LANCASTER COUNTY

ADDENDUM #4

Issue Date: <u>11/14/05</u> SPECIFICATION NO. 05-281

CONSTRUCTION OF COMMUNICATIONS TOWER & PRE-FABRICATED BLDG.

Figure 1 Revised Grounding

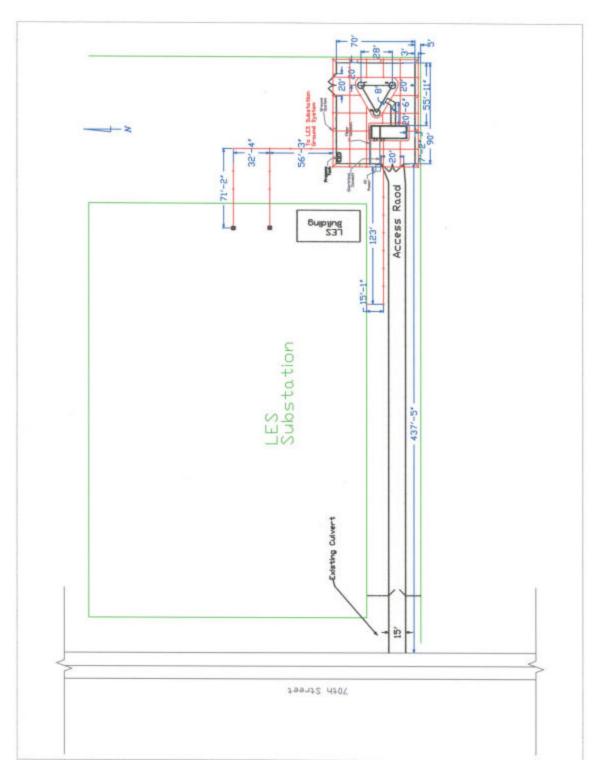
- 1. ADD CHANGE: Because the grounding system for our tower site will be bonded to the grounding system of Lincoln Electric System's (LES) Substation, the engineers at LES have decided that we need to extend our grounding system 3-feet outside of our fence. This addition to our ground grid will help protect an individual should a major fault occur within LES's substation while an individual is in contact with our fence.
 - 1.1 There is no change in the wording of Section 1 Site Development.
 - 1.2 Revised Figure 1 (Page 18) and Figure 2 (Page 19) are included in cad file associated with this addendum
